PLANNING DEPARTMENT

Planning Commission Staff Report

Subject: Treasure
Project #: PL-08-00370
Author: Francisco Astorga, AICP, Senior Planner
Date: 12 April 2017
Type of Item: Administrative – Conditional Use Permit
 Introduction to CUP Criteria 7, 9, 10, & 12

SHEET NUMBER
V-12
6/12/2008

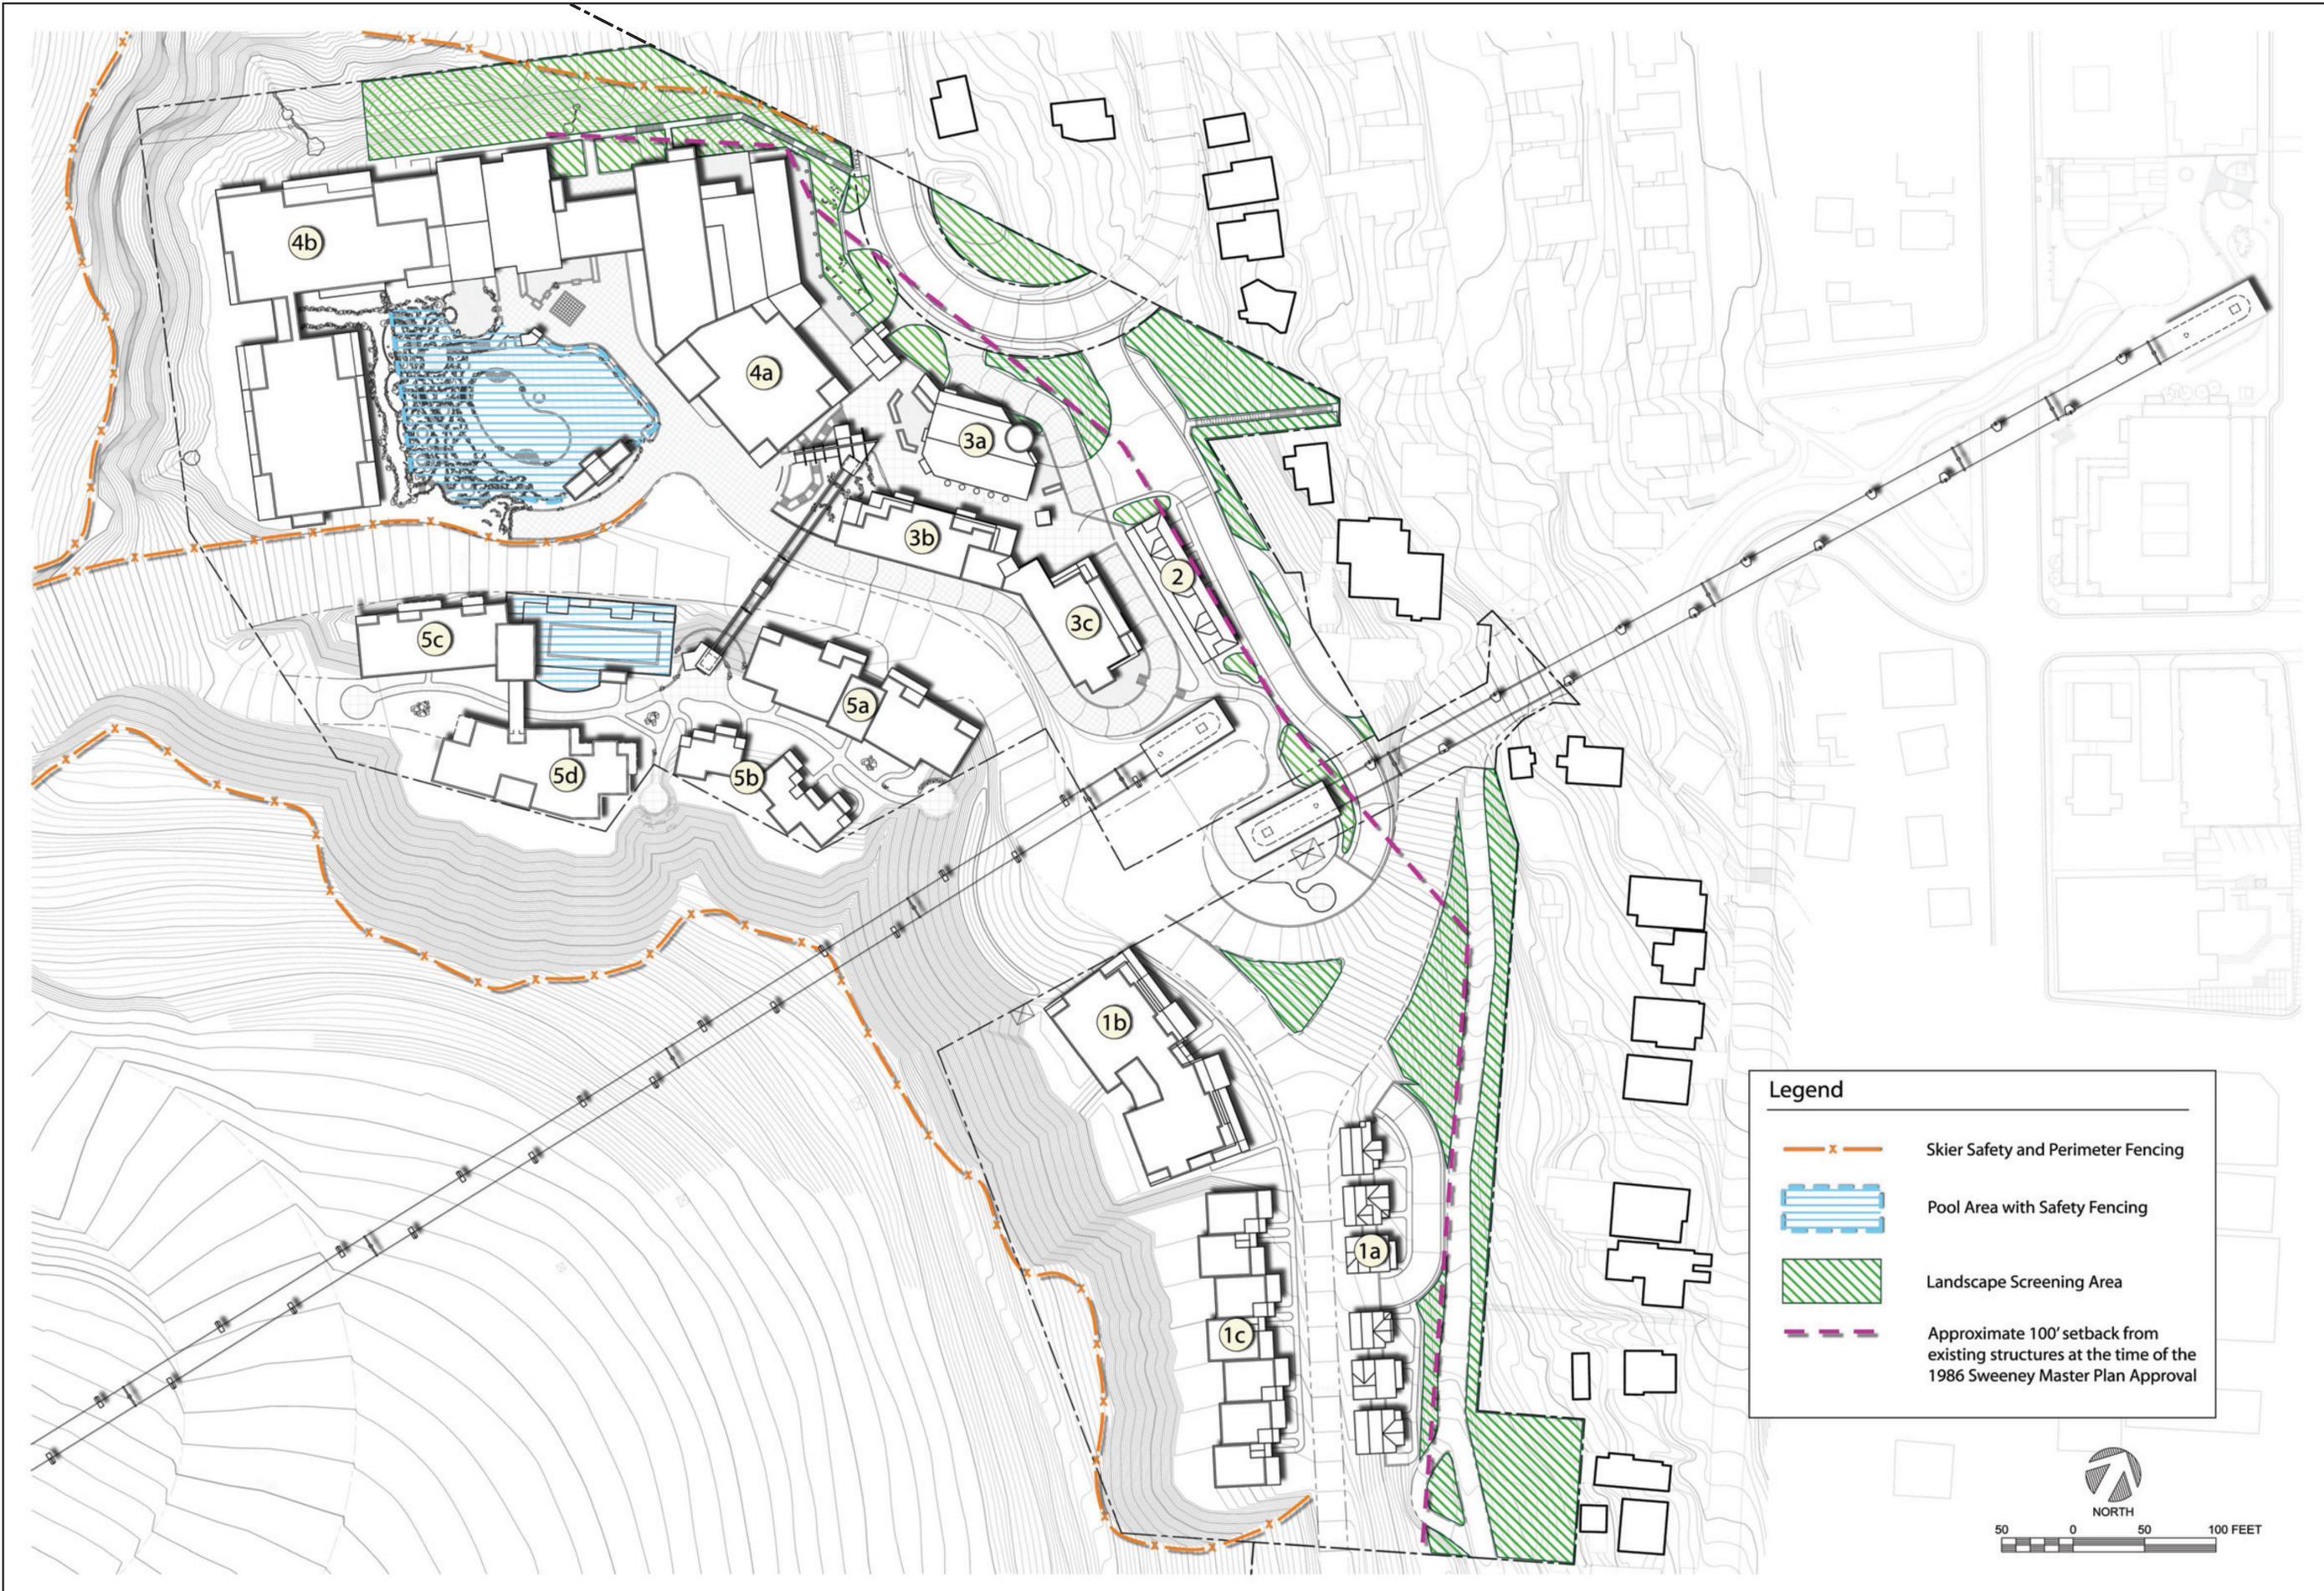
- Criteria #7 – Fencing, Screening, and landscaping to separate the Use from adjoining Uses. The referenced exhibit consists of the site plan with the location of the skier safety and perimeter fencing, pool area with safety fencing, and landscaping screening area. The referenced exhibit and the written/pictorial explanation do not indicate specifics about the proposal, but rather focus on preliminary concepts.

Specifics components need to be reflected on the plans. These components include, but are not limited to, each proposed fence to indicate its proposed material and detail, landscape plan to show proposed plant name (botanical name, common name, etc.), quantity, size location, and spacing, etc., each proposed mitigation strategy needs to be listed and identified.

V-11

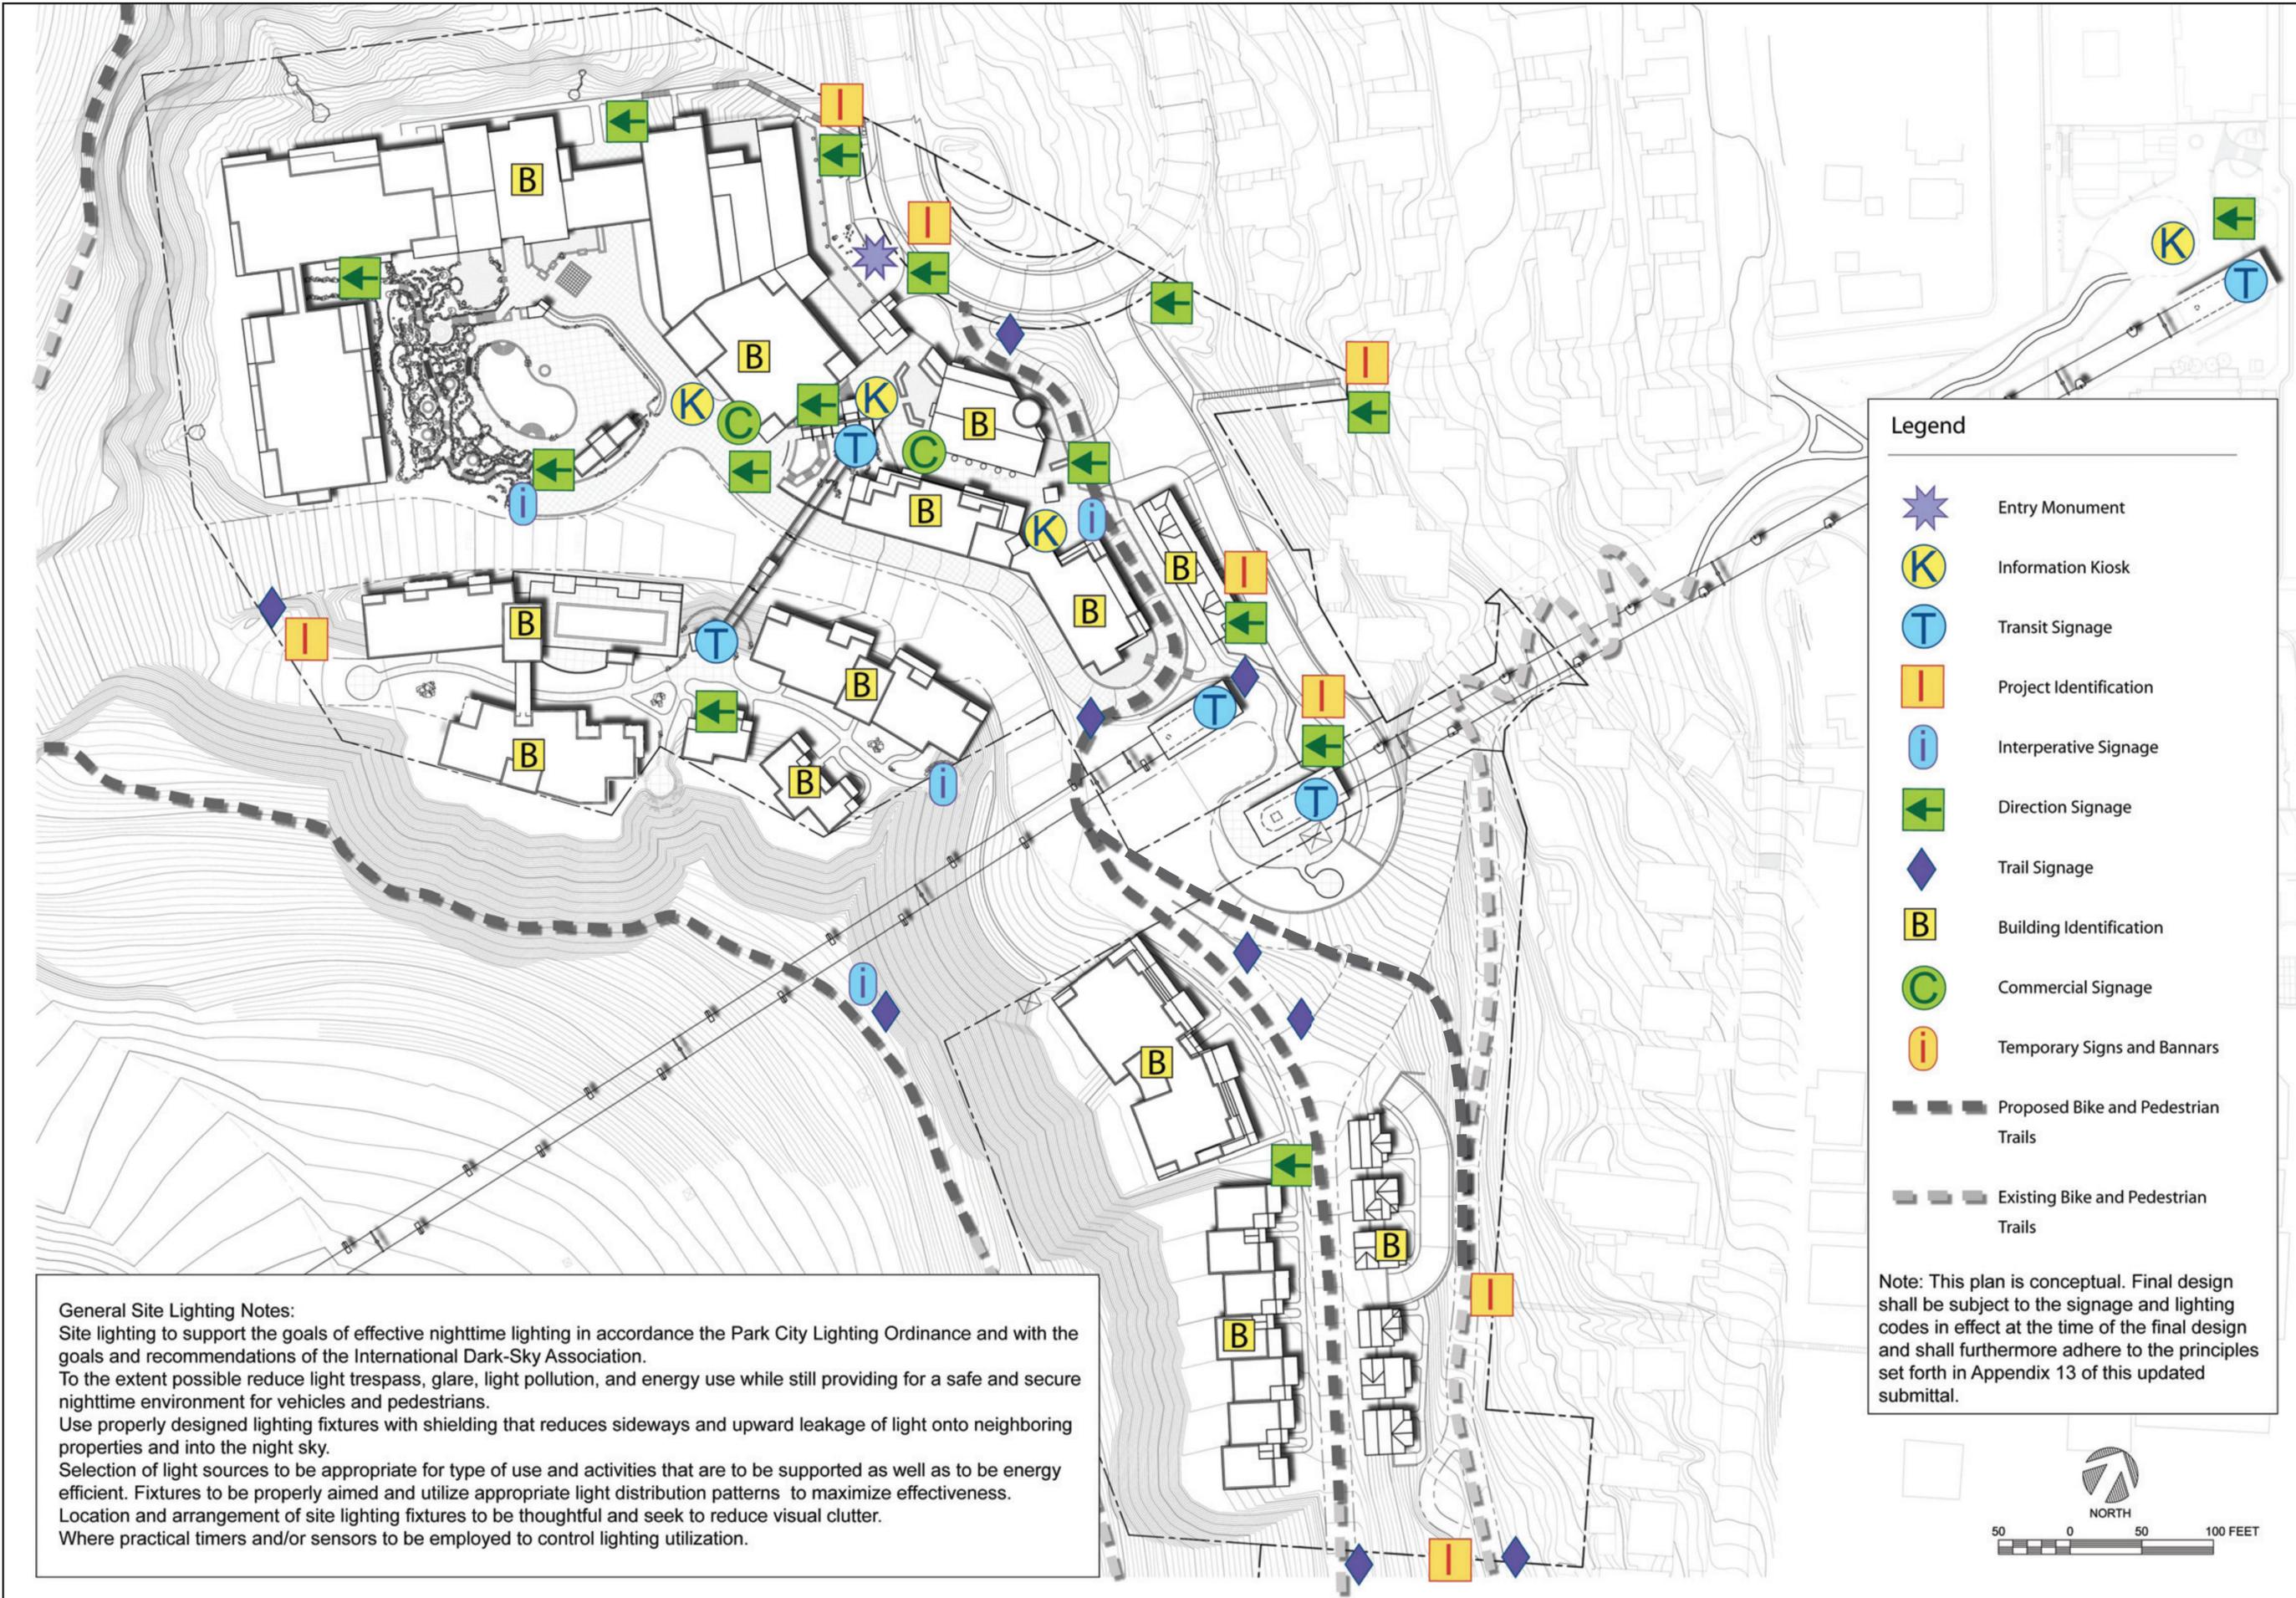
The applicant indicates that the two (2) sites contain a combined of 70% open space. [Sheet SP.1 - Site & Circulation Plan](#) shows that the Mid-station site is 3.75 acres and contains 84.94% of open space. The same sheet SP.1 shows that the Creole Gulch site is 7.75 acres and contains 70.58% of open space. The entire area consisting of 500,928 square feet or 11.5 acres contain a total of 75.26% open space. The applicant submitted the referenced exhibit [Sheet V-11 - Usable Open Space within Development Parcels](#) which shows the three (3) categories identified as Open Space not intended for Recreation use, usable Open Space, and dedicated open space outside of project area:

Discussion Requested: Staff finds that the proposal complies with the open space requirements identified in the Sweeney Properties Master Plan. Does the Planning Commission agree with this?

SHEET NUMBER
V-13
6/12/2008

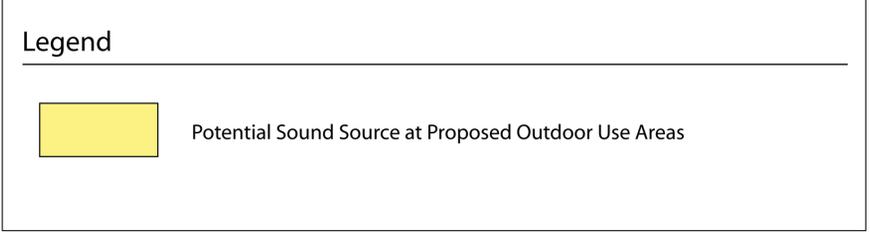
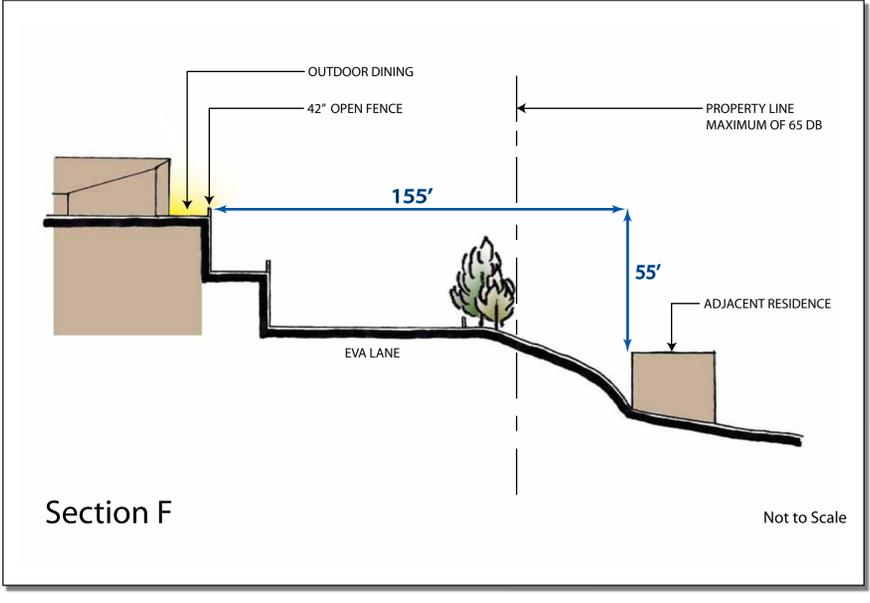
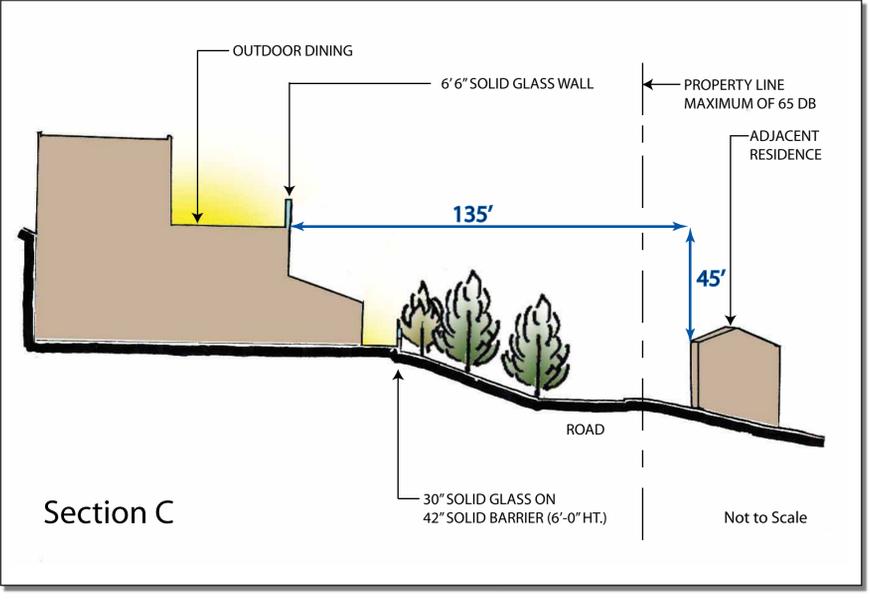
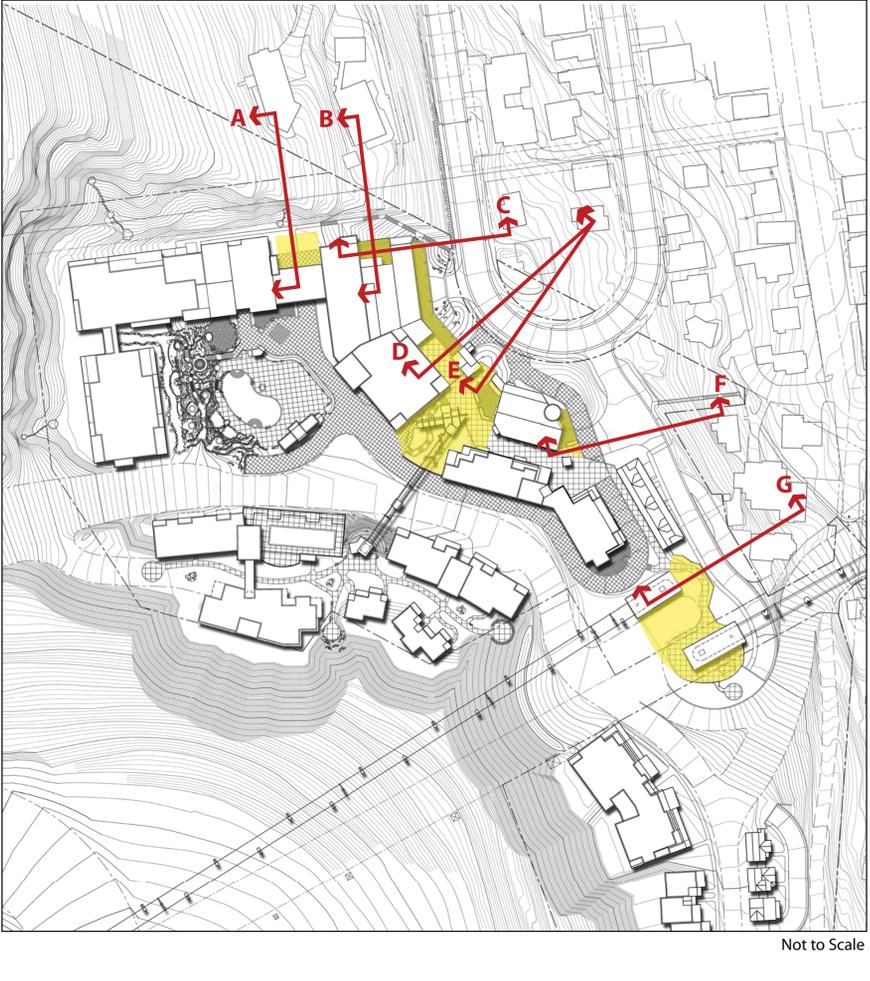
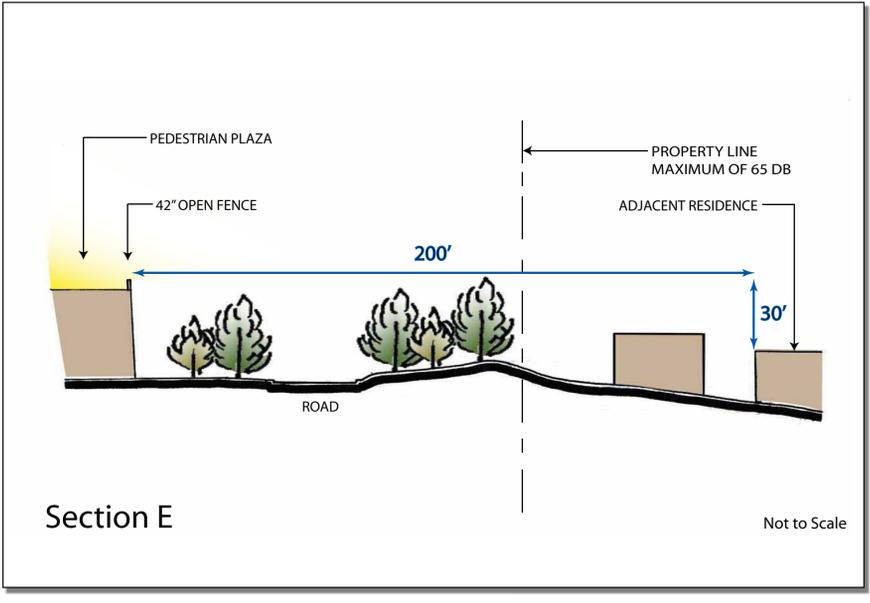
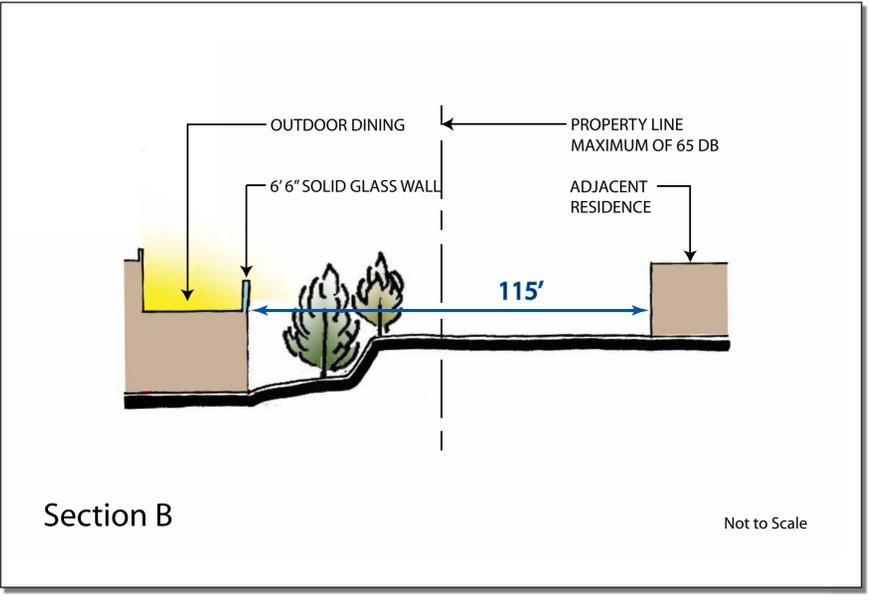
- Criteria #12 – noise, vibration, odors, steam, or other mechanical factors that might affect people and Property Off-Site. The referenced exhibit consists of seven (7) cross sections with recognized potential sound source at proposed outdoor use areas and the distance to adjacent residences outside the development. The referenced exhibit and the written/pictorial explanation do not indicate specifics about the proposed mitigation for vibration, odors, steam, or other mechanical factors that might affect people and property off-site, other than the distance from potential sound source at proposed outdoor use areas.
